**Committee of the Whole
Meeting Minutes
Tuesday, August 25, 2026
8:30 AM**

Prime Contract Change Order #003: RFI #8: Gymnasium - Chimney Demolition Concealed Conditions

Prime Contract Change Order #004: CE #022 - RFI 15 & 17 Electrical Changes

Prime Contract Change Order #006: CE #018 - RFI #14: Auditorium - ADA Elevator Access and Ramp

2 CONCESSIONS FLOOR REINFORCEMENT E/W SECTION

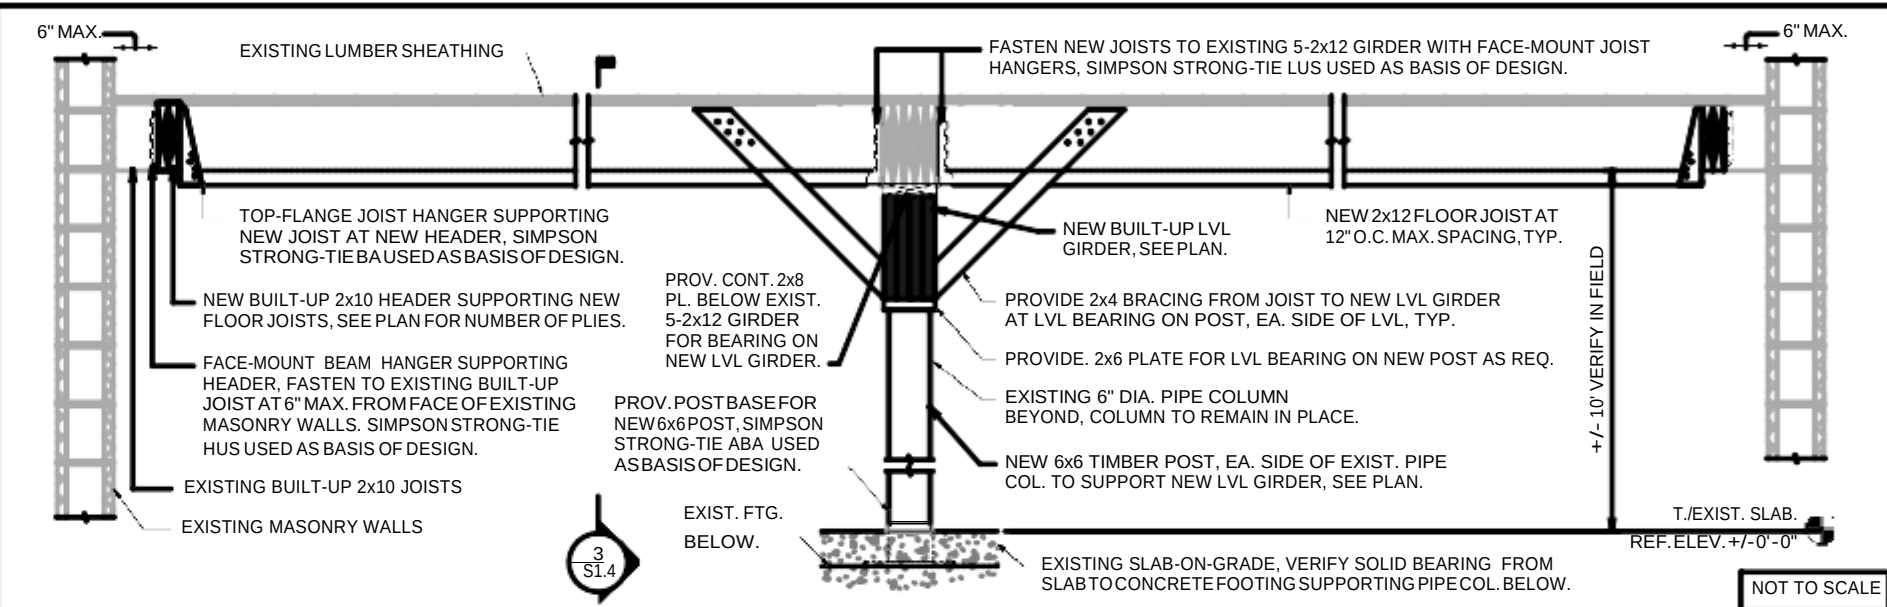
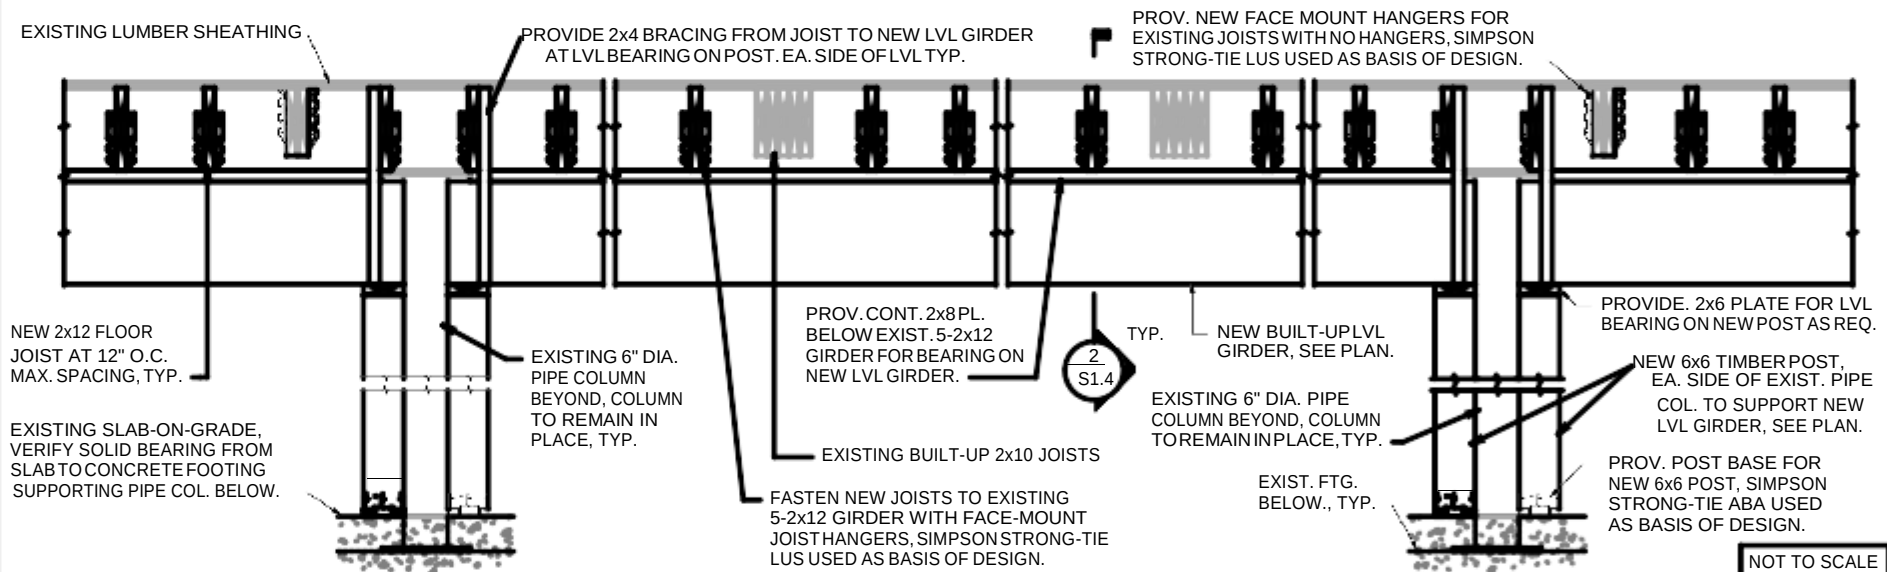
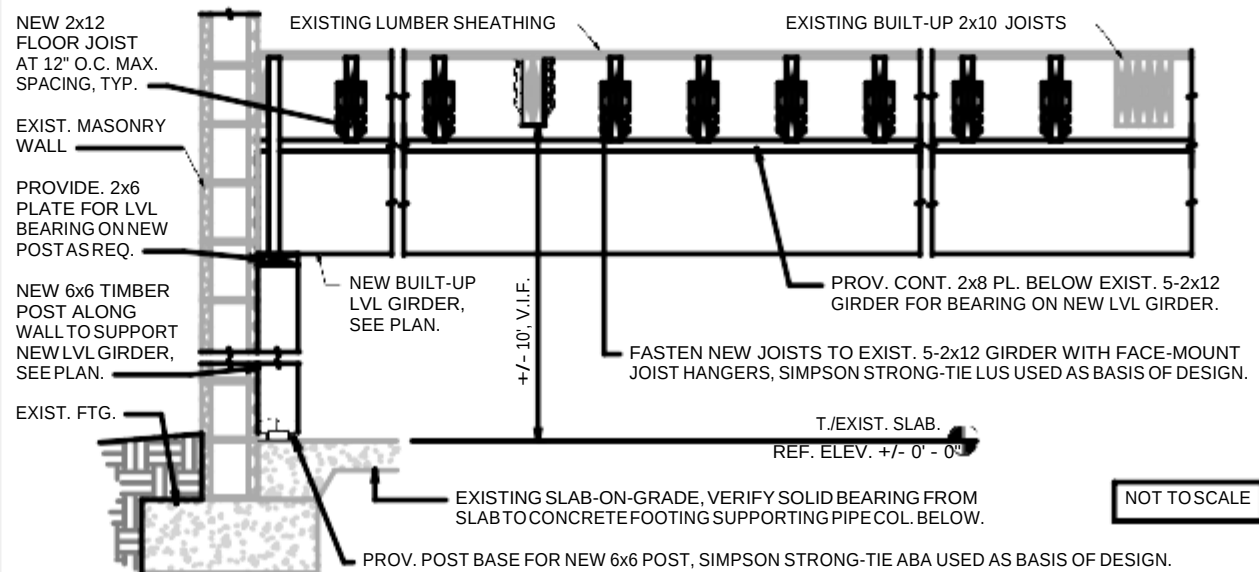
Description of change: Pottery Area LVLs and joist per structural concession floor plan Sheet S1.4

2. FASTEN LVL PLIES TOGETHER WITH (3) ROWS OF 12d COMMON NAILS THROUGH EACH FACE AT 12 INCHES ON CENTER IN ACCORDANCE WITH THE MANUFACTURER'S SPECIFICATIONS. REFER TO THE MANUFACTURER'S SPECIFICATIONS FOR ALTERNATIVE BUILT-UP LVL FASTENING OPTIONS.

3. THE EXISTING LUMBER GIRDER SHALL BEAR SOLID ON THE NEW LVL GIRDERS. PROVIDE SHIMS AS REQUIRED TO ACHIEVE SOLID BEARING, SEE TO SECTIONS.
4. CONTRACTOR SHALL VERIFY ALL EXISTING CONDITIONS AND DIMENSIONS REQUIRED. ANY DISCREPANCIES BETWEEN FIELD CONDITIONS AND THESE DOCUMENTS SHALL BE REPORTED TO AVERY ENGINEERING PRIOR TO CONSTRUCTION.

5. ALL NEW DIMENSION LUMBER FRAMING MEMBERS TO BE SOUTHERN PINE NO.2 MINIMUM GRADE LUMBER, TYP.
6. IF EXISTING WOOD FLOOR FRAMING COMPONENTS DISPLAY EVIDENCE OF WOOD ROT, TERMITE DAMAGE, OR SIMILAR DAMAGE, CONTRACTOR TO COORDINATE WITH OWNER, ARCHITECT AND AVERY ENGINEERING ON REMOVAL AND REPLACEMENT OF EXISTING DAMAGED FRAMING COMPONENTS.
